TERM CONTRACT
Project Agreement No. 1 to
CBJ Construction Services for Small Civil and Utility Projects
Term Contract No. RFP E19-192(E)

South Franklin Stanchion Installation

To: Alec Venechuk
Subject: RE: [EXT] FW: S. Franklin bollard pics

Bollard R-7236

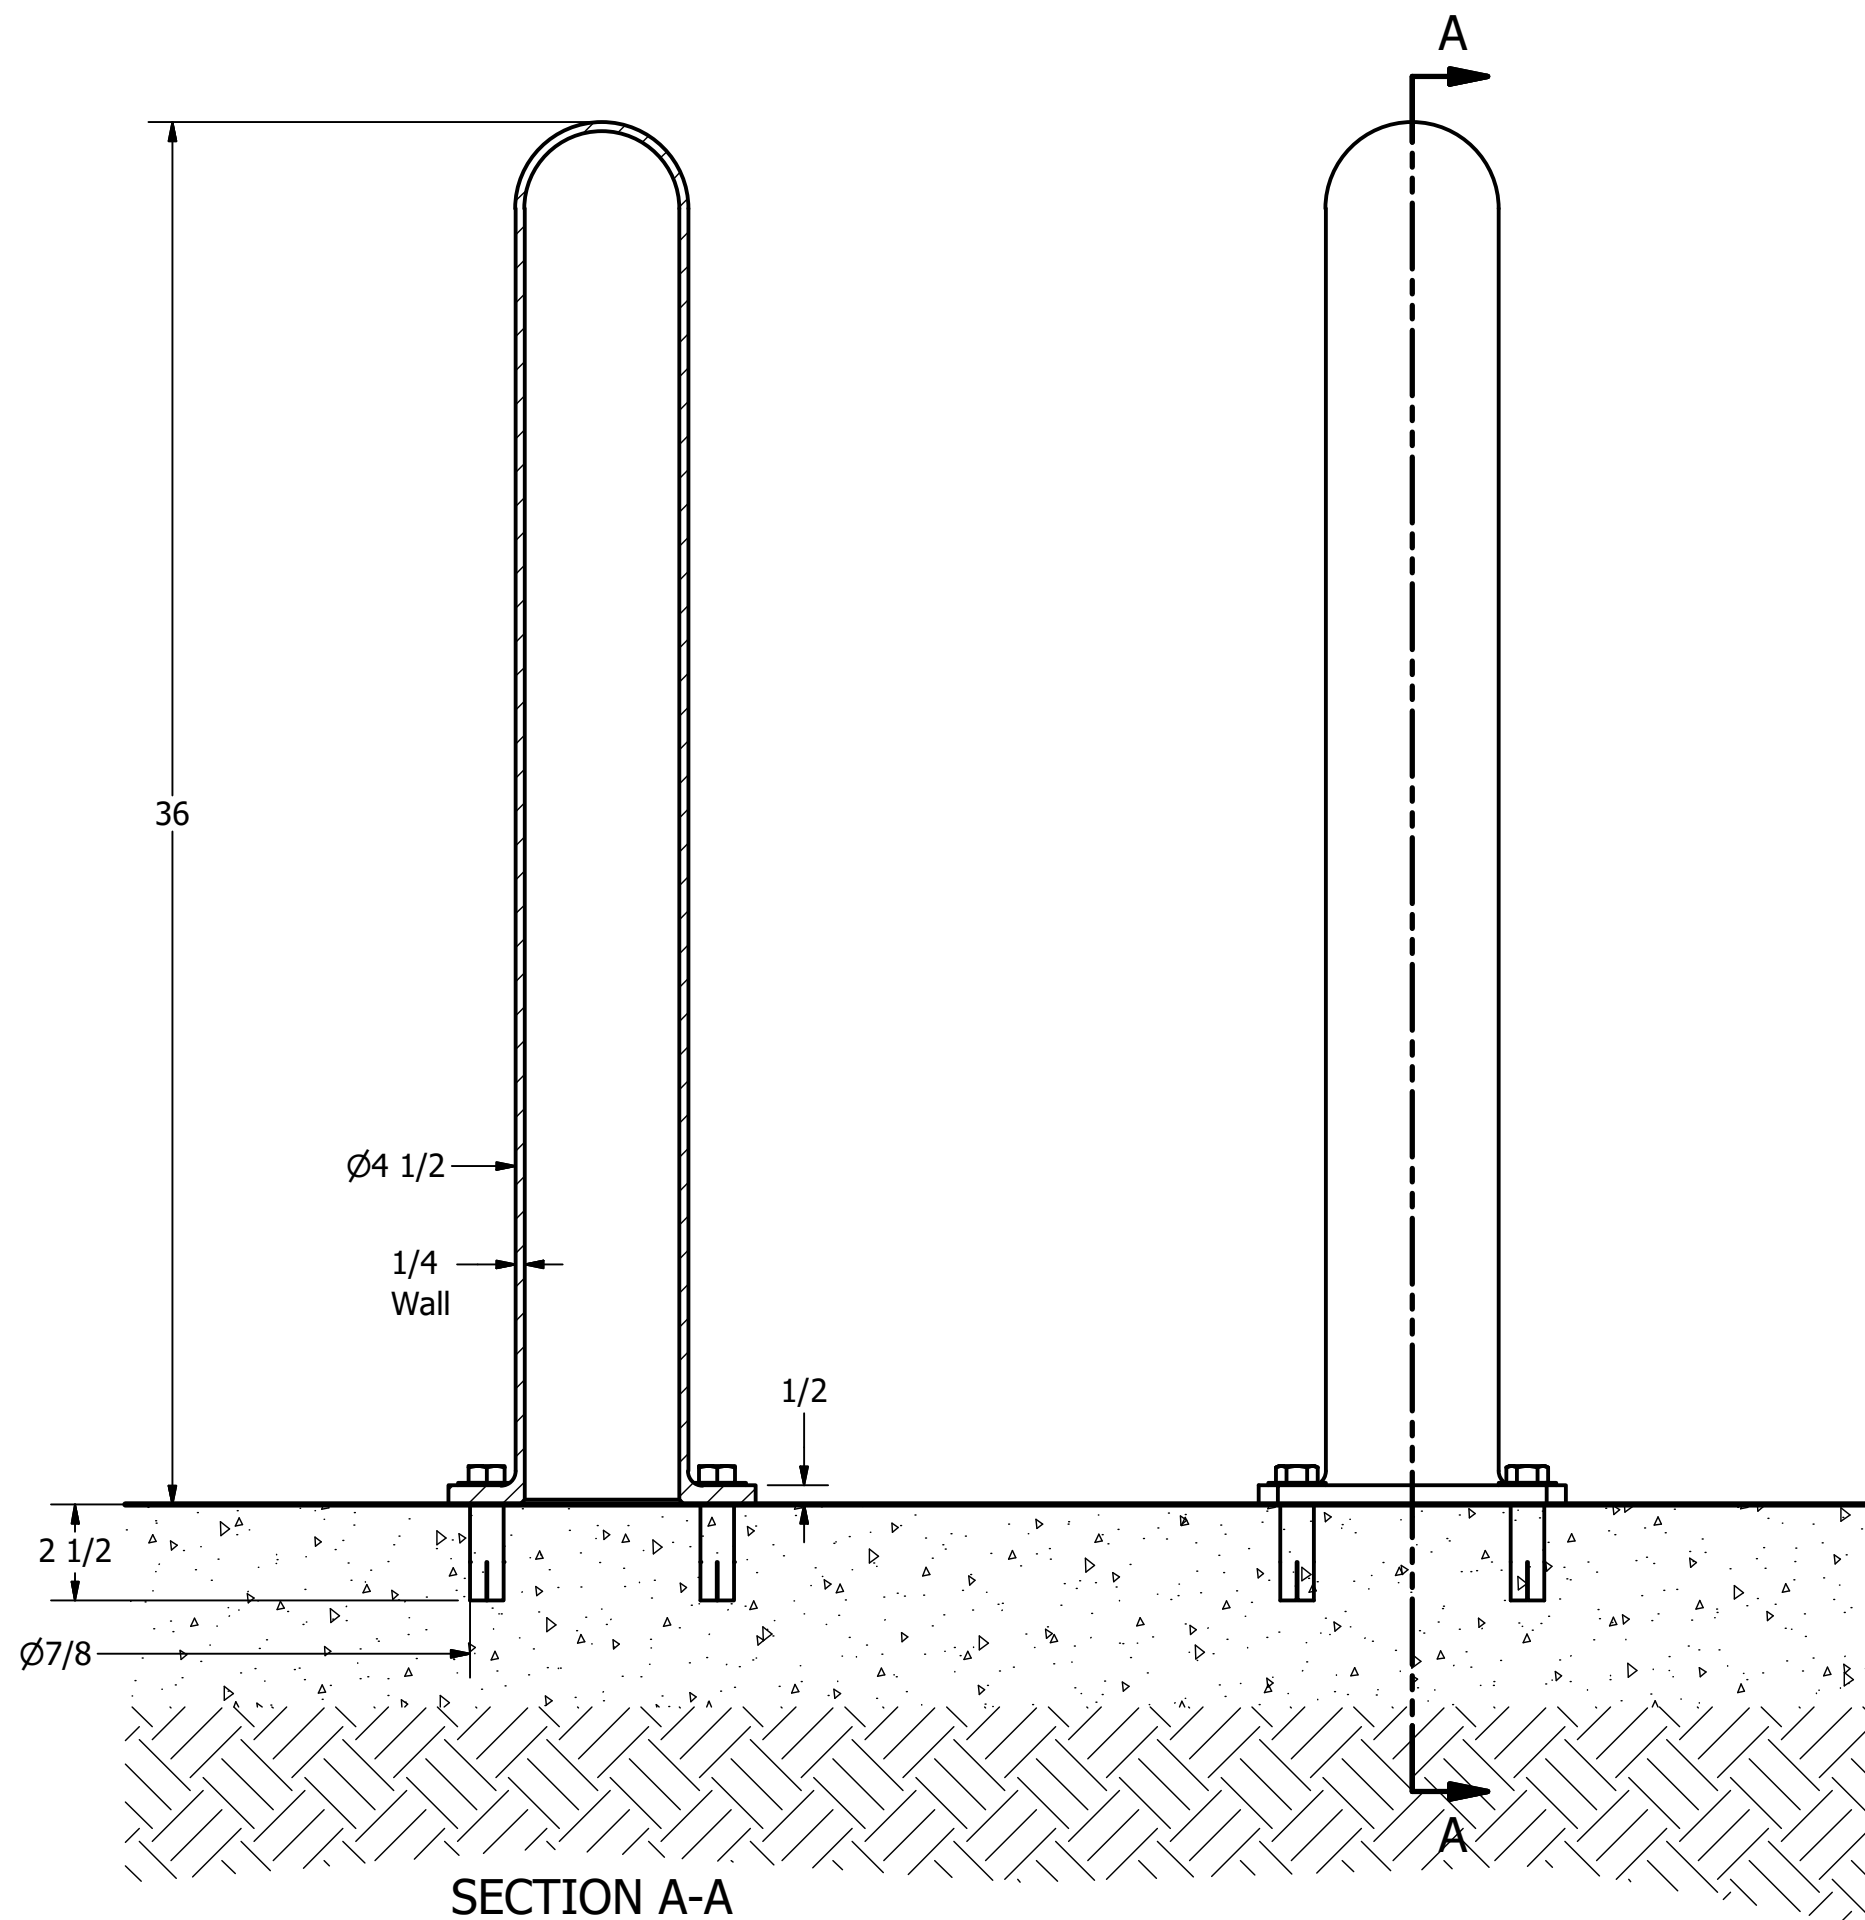
For what it's worth, when I called Reliance about lead times last month the information I received reflected the change from R-7902 to R-7236.

Alec, bad news. The model already installed and in the pictures is not the specified R-7902. Appropriate model is the R-7236. 7236 has the attached square flange and is slightly larger in OD. The 7902 does not have the same style square base, it's base stays attached to the sidewalk. As a check, they dug into their archives and pulled Arete's order and it is confirmed the same as delivered last year. Also, additional requests were made as well. Previous order requested the chain eyes to be bolted and not welded as shown in the provided detail. Drilled locations were requested to be at 6" and 18". Not at the specified 6" and 12" as shown on detail. The bad news is they already drilled the wrong bollards. I've been told this will cost but have not received an answer on amount or time involved in making the correct bollards. I assume you would like to have the order corrected to have the same same. If they want the bollards paid for it'll be a 10k addition. Let me know what direction to go asap to keep from further stalling things out.

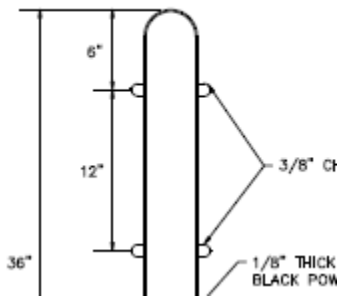
I was not aware of an issue with the chain heights. I believe Jer may have mis-read the detail which shows the chain eyes at 6" and 18" from the top of the bollard. The lower eye is 12" below the upper eye, and not 12" below the top of the bollard. See below.
